Appl. No. 10/084,320
Amdt. dated August 26, 2005
Reply to Office action of March 28, 2005

Amendments to the Drawings:

Annotated Sheet Showing Changes

FIG. 7

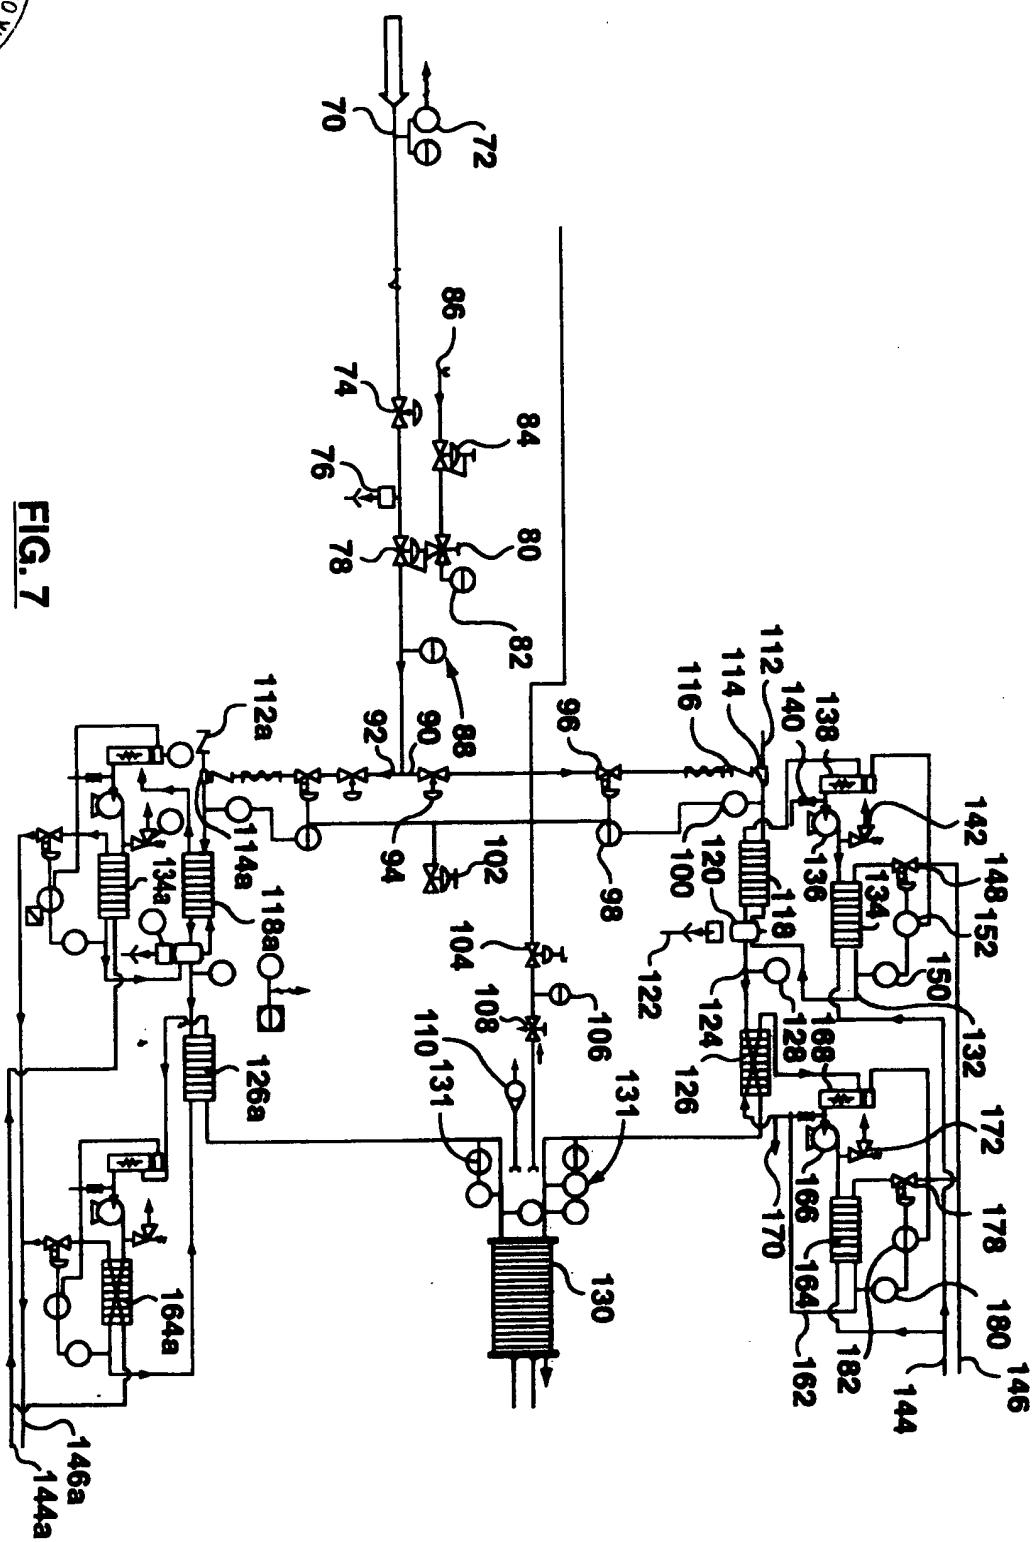
The attached sheet of drawings includes changes to Fig. 7. This sheet, which includes Fig. 7, replaces the original sheet including Fig. 7.

Firstly, to clarify the disclosure in the application, an amended Figure 7 is attached. The bottom portion of Figure 7 showing the components and the oxidant supply line are simply being amended to correspond to the corresponding components at the top of Figure 7 for the fuel supply line and also to correspond with the originally submitted, informal copy of Figure 7. As the Examiner is aware, the specification at page 9, lines 6-10 indicates that many of the elements in the two lines 90 and 92 are similar and have the same function, with those in the line 92 being designated by the suffix "a". Accordingly, no new matter has been added.

Figure 7 is being amended, so that the part of the cooling circuit for the oxidant stream that corresponds with the cooling circuit for the fuel stream is now shown more fully. As noted at page 9, lines 6-10 of the specification, it is made clear that the

circuits for the fuel and oxidant gases generally correspond. Some connections to heat exchangers 118a and 134a (newly designated), corresponding exactly to the connections for the heat exchangers 118, 134, are now shown. The inlet line for the second coolant is now shown at 144a, corresponding to line 144 at the top of Figure 7. No new matter has been added.
